SAN FRANCISCO PLANNING DEPARTMENT

Addendum to Environmental Impact Report

Approval Date: May 15, 2013
Case No.: 2007.0347E
Project Title: Modified Project 7-3: Great Highway and Point Lobos Avenue
Bicycle Lanes
EIR: San Francisco Bicycle Plan
SCL No. 2008032052, certified August 4, 2009
Zoning: n/a, in public right-of-way
Block/Lot: n/a, in public right-of-way
Lead Agency: San Francisco Planning Department
Project Sponsor: San Francisco Municipal Transportation Agency
Kristiann Choy, Project Manager - 415.701.2493 - kristiann.choy@sfmta.com
Staff Contact: Monica Pereira – 415.575.9147 - monica.pereira@sfgov.org

APPENDIX B
Modified Project 7-3 Eastern Extension

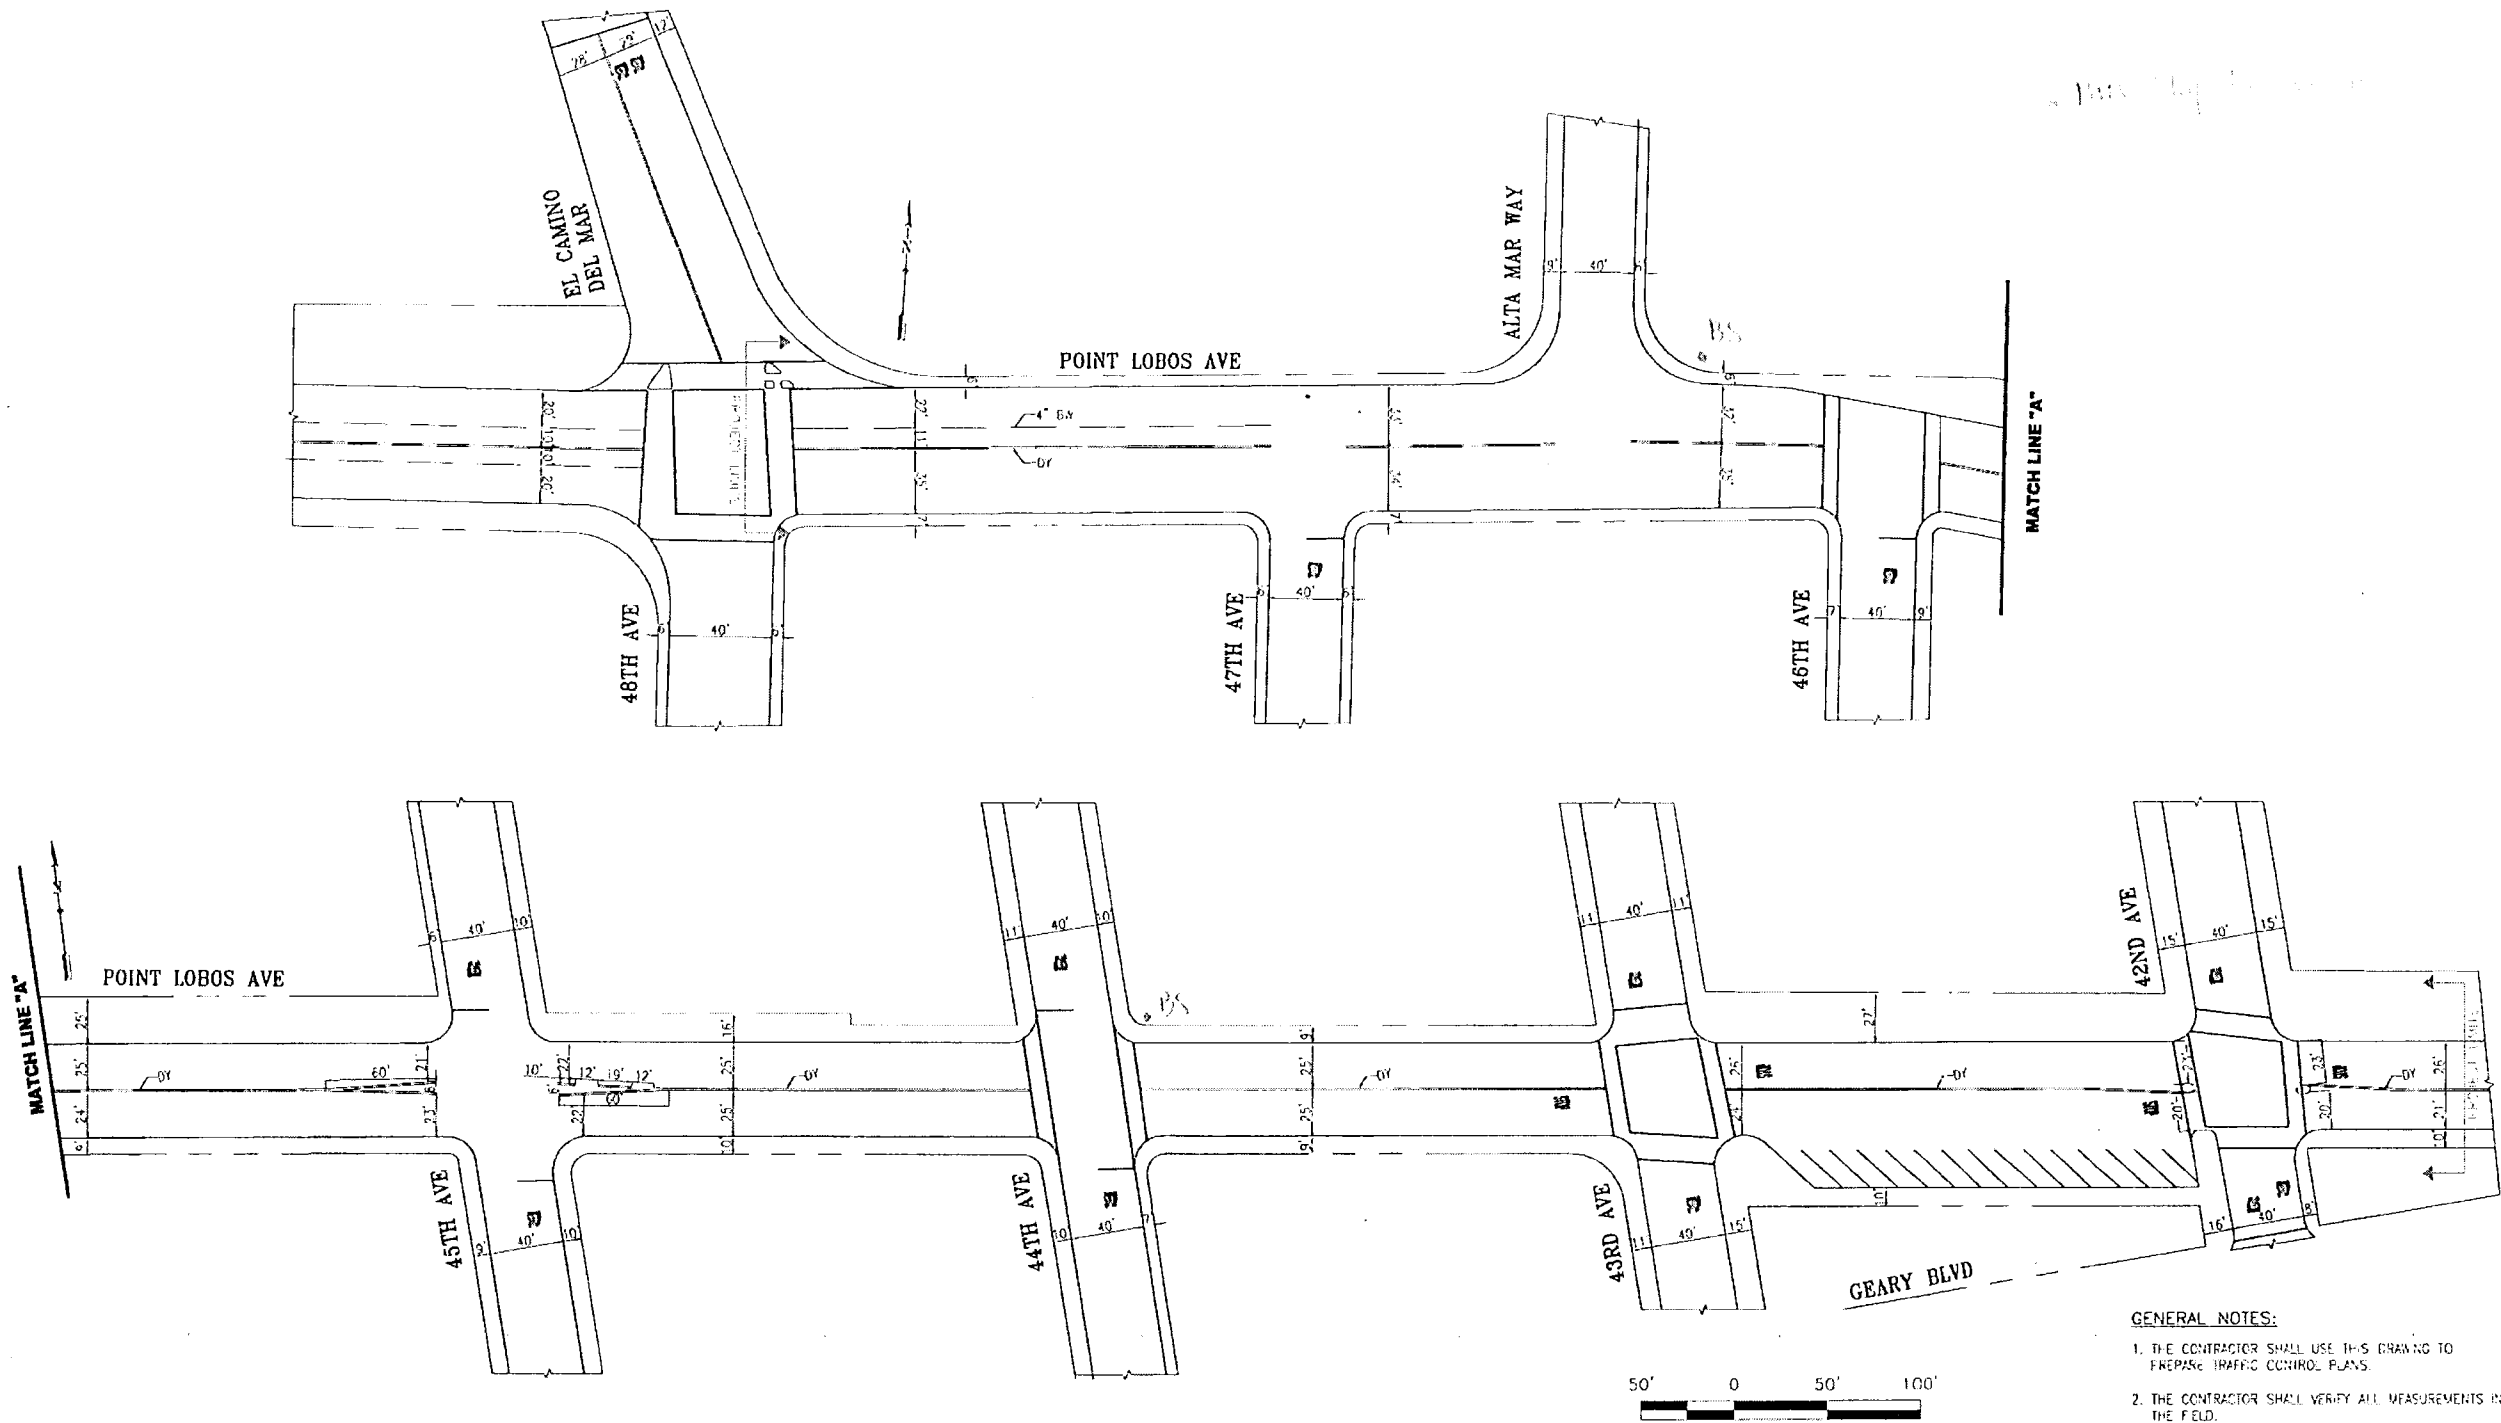
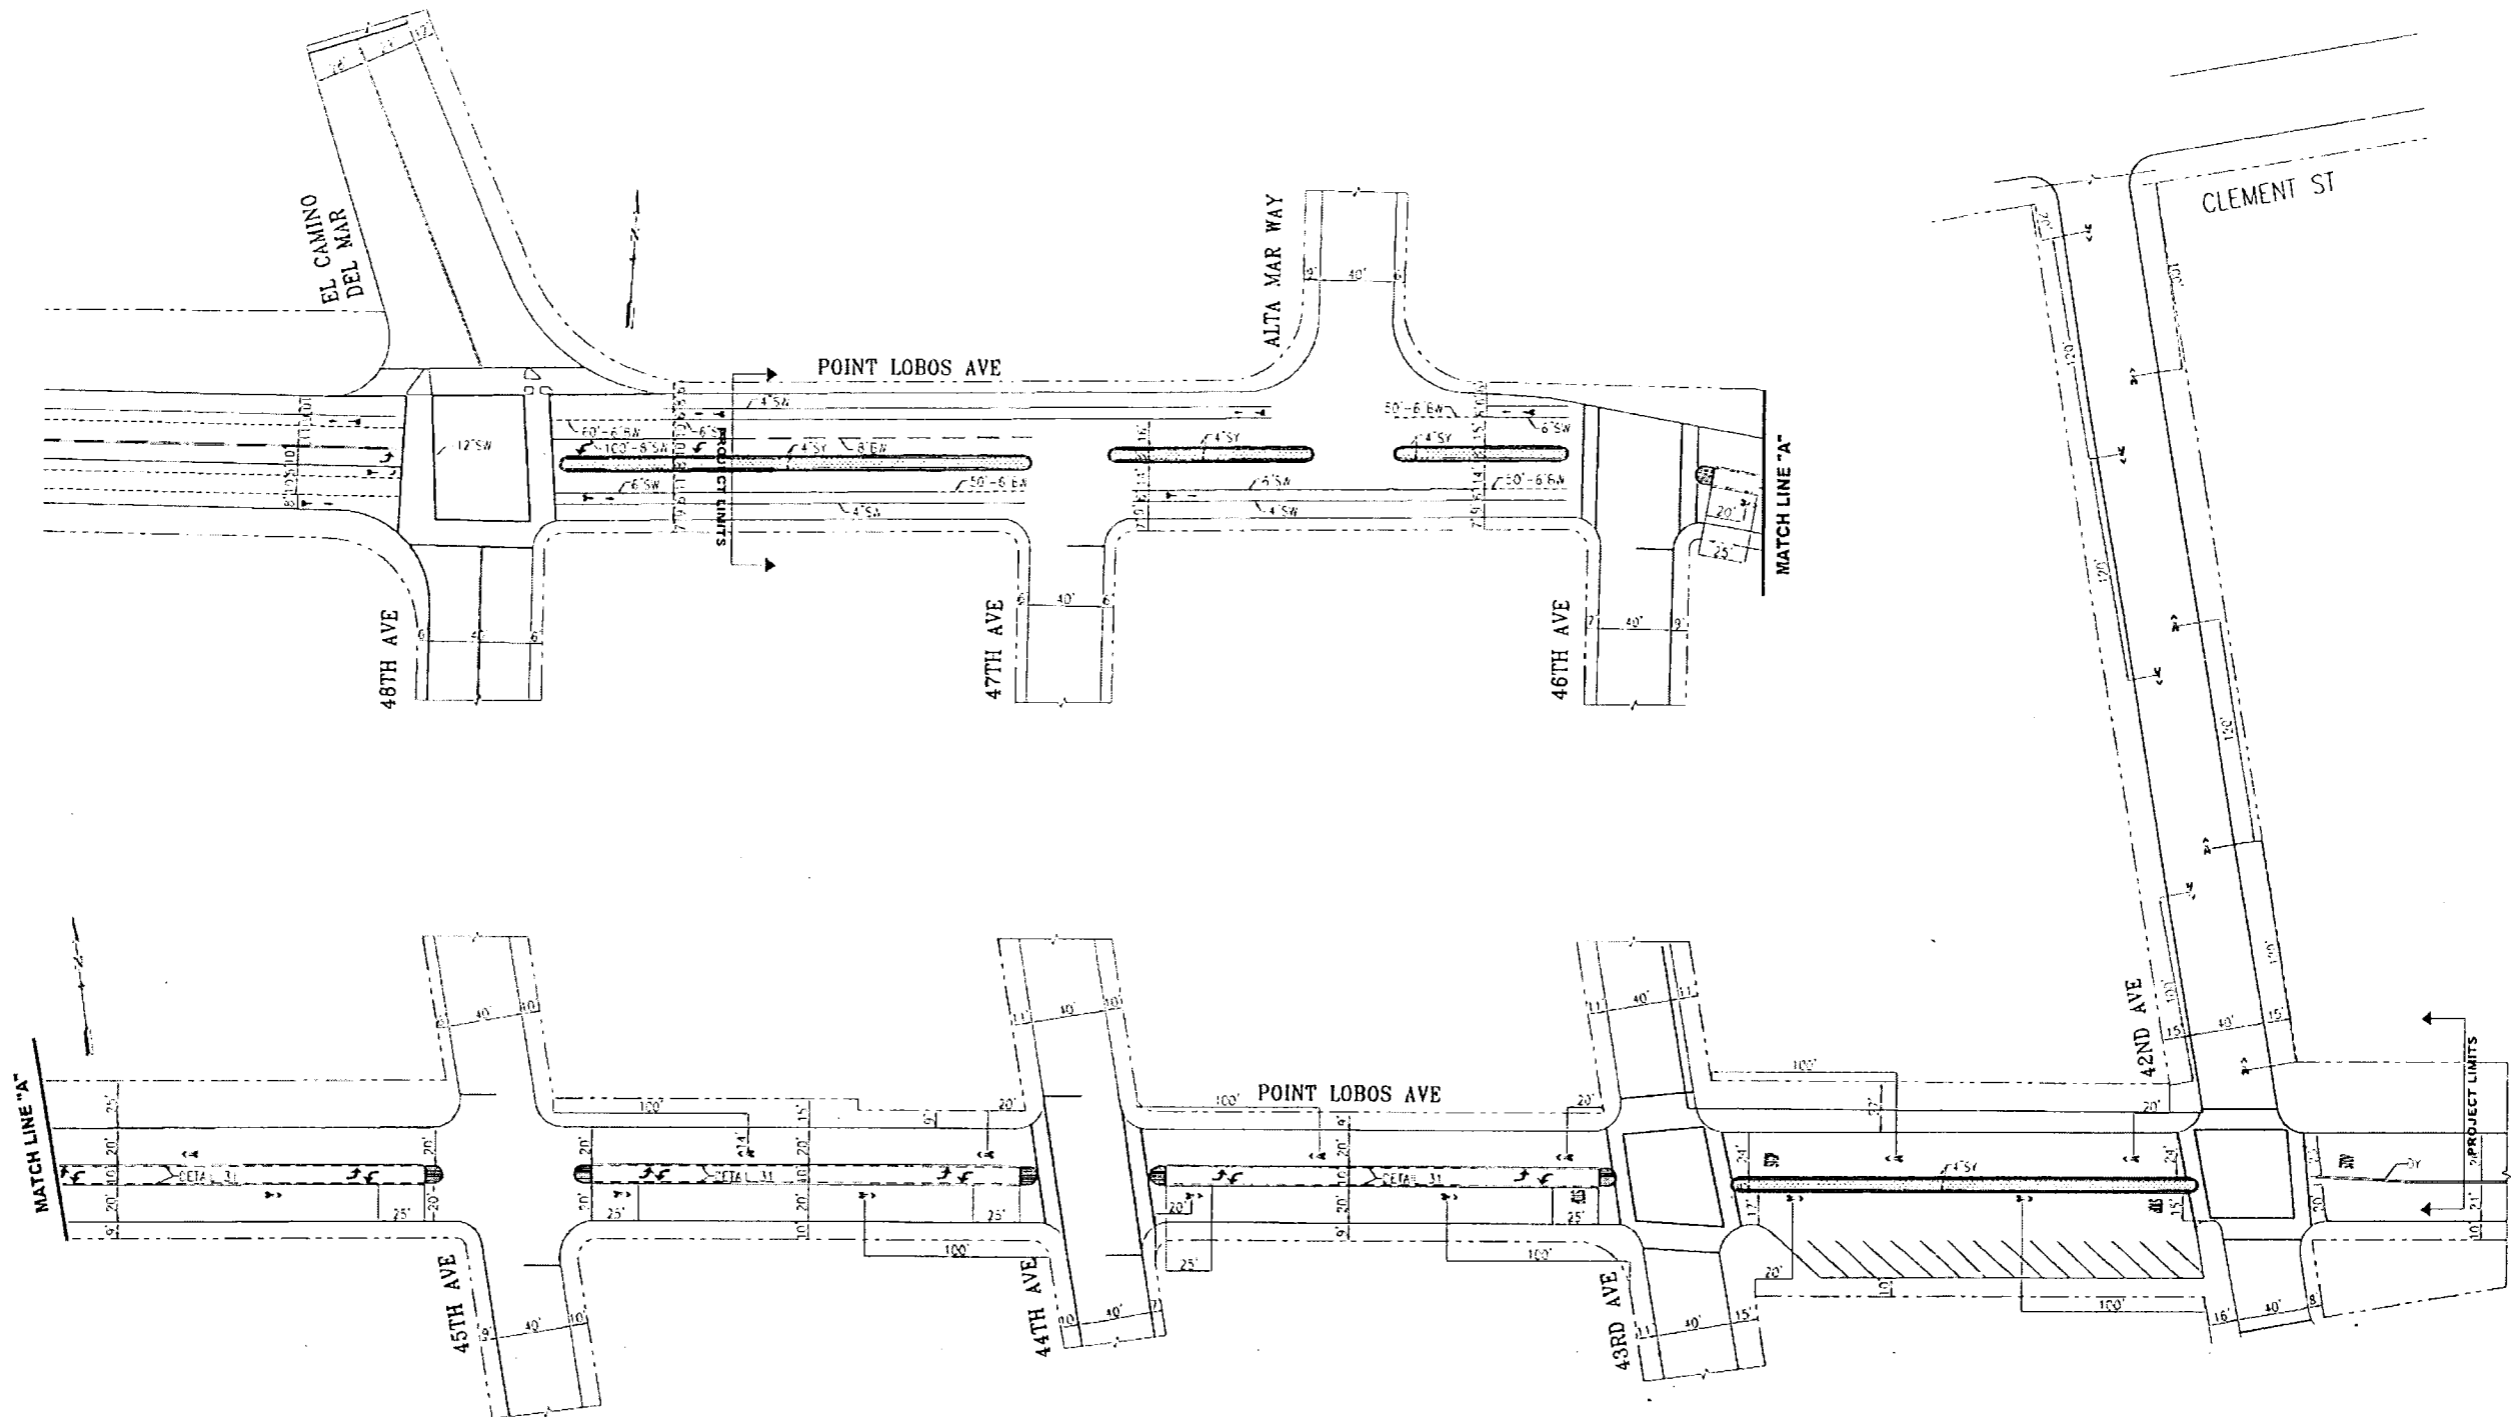
- Expand the limits of Modified Project 7-3 by extending Class II bicycle lanes, in each direction, on Point Lobos Avenue east of 48th Avenue to 46th Avenue. The bicycle lanes would be added by removing one eastbound through lane between 48th and 46th Avenues and one westbound through lane between 47th and 46th Avenues. It would also narrow travel lanes in each direction in this roadway segment. Sharrows⁴ would be provided in the travel lanes on Point Lobos Avenue between 46th and 42nd Avenues. Sharrows would also be provided in the travel lanes on 42nd Avenue between Point Lobos Avenue and Clement Street.

- Modify the westbound approach of the 48th Avenue/El Camino Del Mar/Point Lobos Avenue intersection to provide one left-turn lane and one shared through/right-turn lane.

- Add landscaped raised medians on Point Lobos Avenue between 48th and 47th and 43rd and 42nd Avenues; add landscaped islands⁵ between 47th and 46th Avenues.

- Add two-way-left-turn-lanes on Point Lobos Avenue between 45th and 43rd Avenues.
- Add thumb nail islands⁶ on Point Lobos Avenue as it intersects with 46th, 45th, 44th and 43rd Avenues.
